Re: Watts Bar Nuclear Plant  
NPDES No. TN0020168

RE: Application No. TN0020168  
Public Notice No. 78TN006  
NPDES Permit Application  
Tennessee Valley Authority  
Watts Bar Units 1 and 2

WATTS BAR NUCLEAR PLANT - WATER USE DIAGRAM

NPDES NO. TN0020168

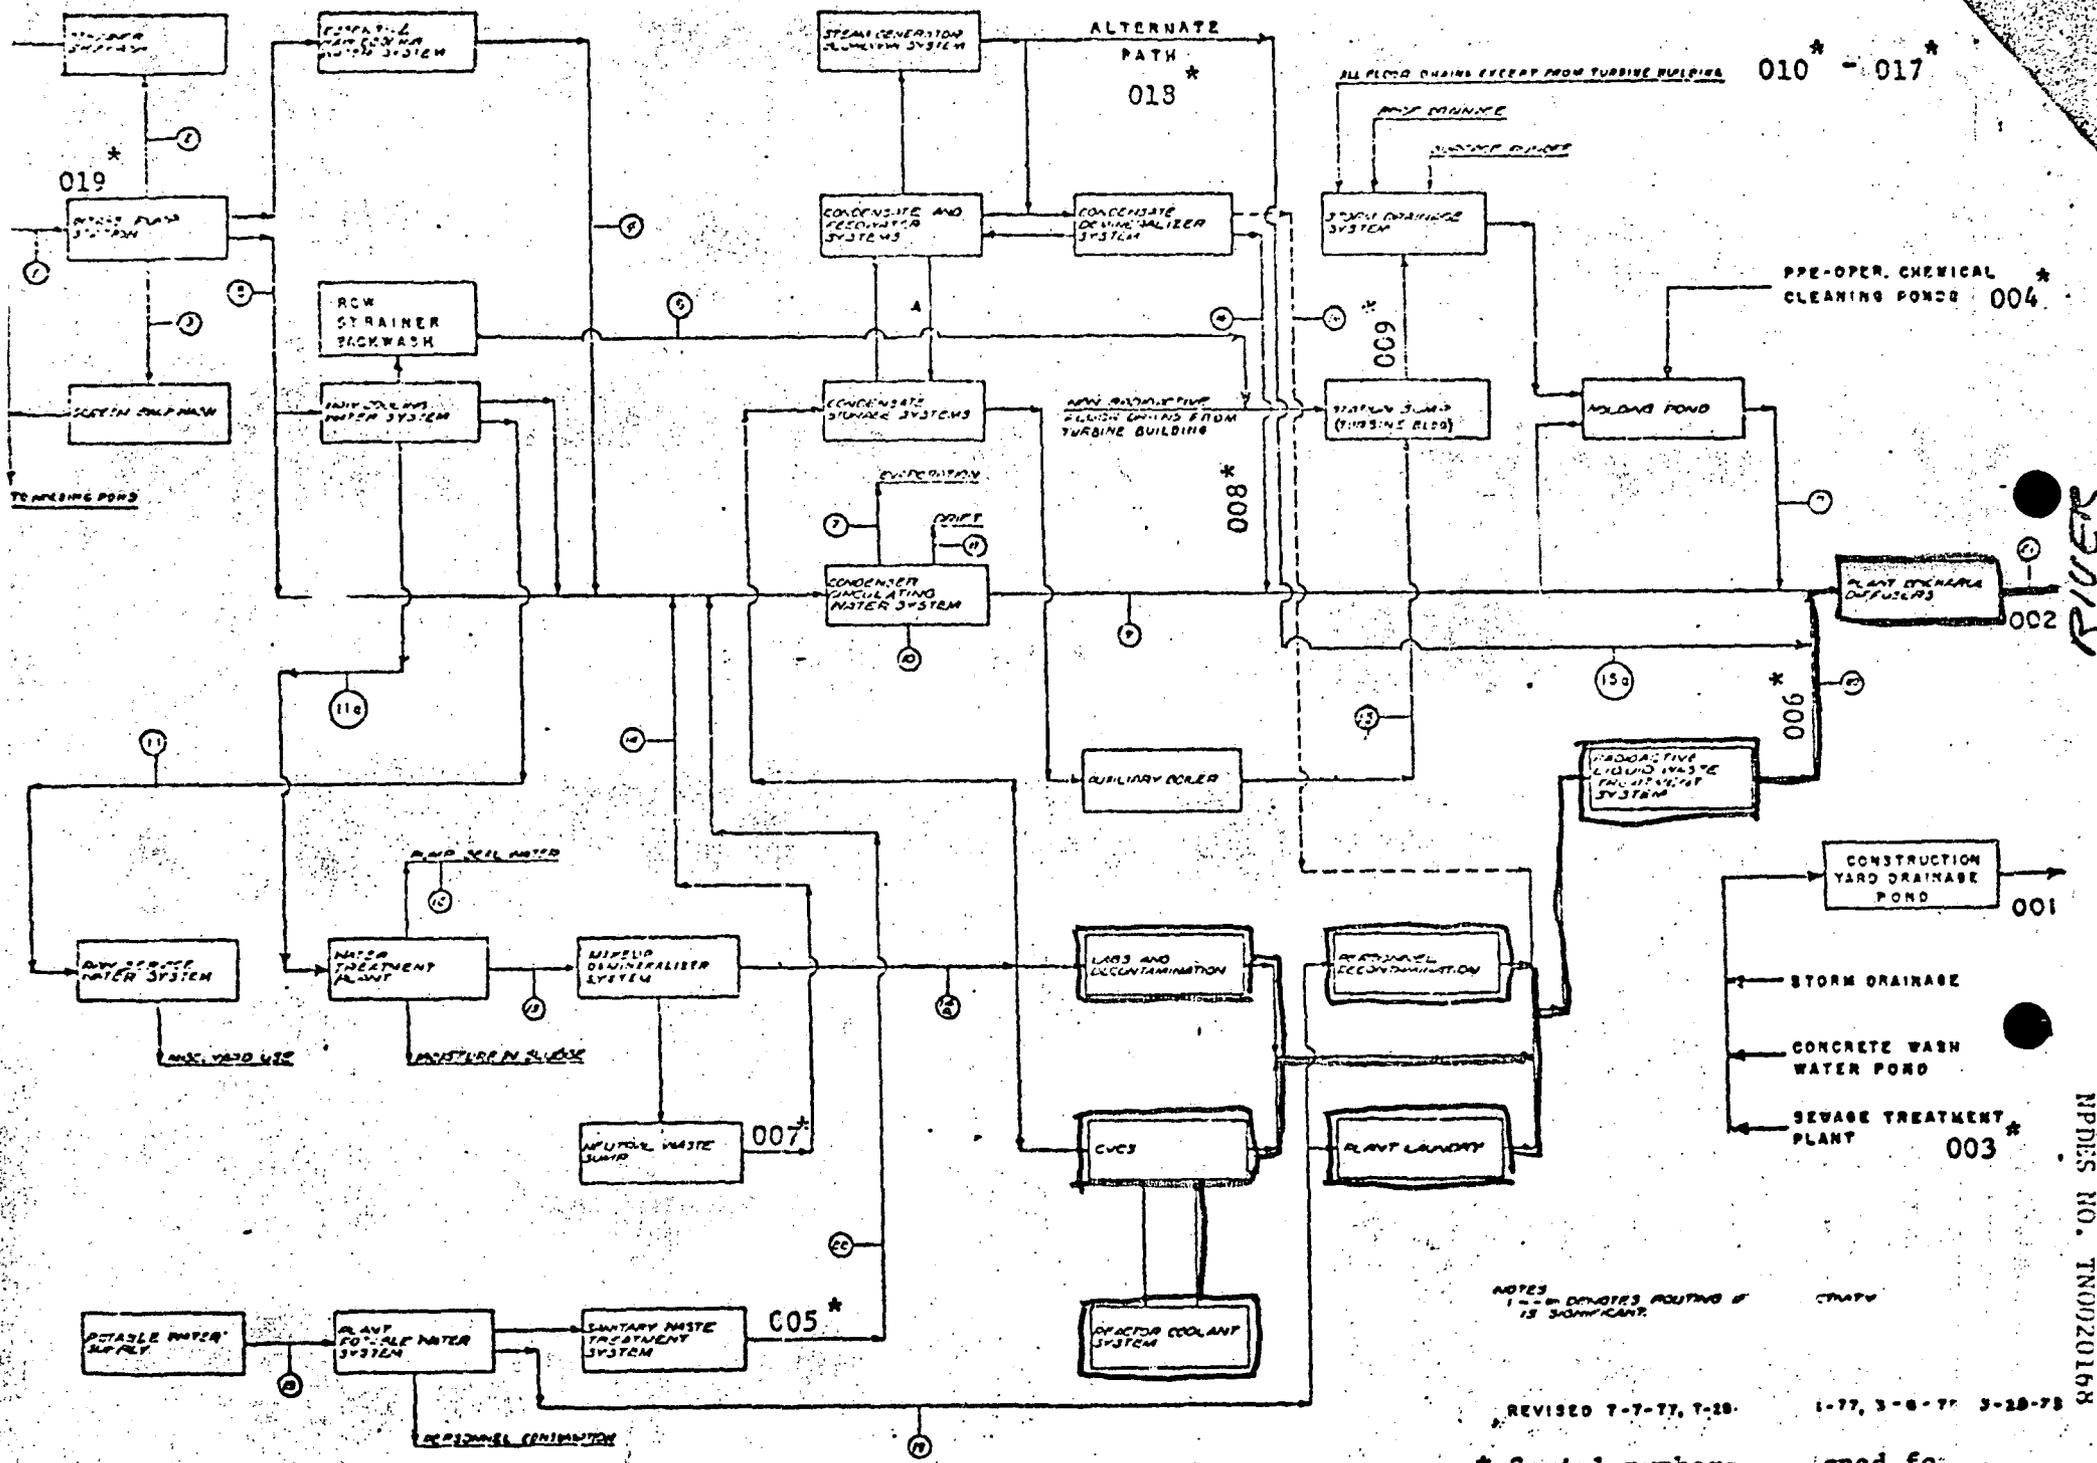
I agree to be subject to examination on all matters contained herein at our own expense. Areas which I contest are those set out in the Application's section 1.e., page 1, Proposed Pollution Abatement Facilities--neutralization and/or sedimentation of plant operating wastes; and PART I, Section A, page 7, EFFLUENT LIMITATIONS AND MONITORING REQUIREMENTS--Liquid Radwaste System. The part of the system I am concerned with is outlined on the diagram I enclose.

(1) Applicant-permittee proposes to limit discharges to the Tennessee River to 15 mg/l average and 20 mg/l maximum liquid radwaste daily. Dilution factors--the mg/l notation--make no indication of the weight, activity, persistence, or biological effectiveness of the suspended solids comprising the liquid radwaste discharge. Such indications are necessary for any realistic assessment of potential damage to biota.
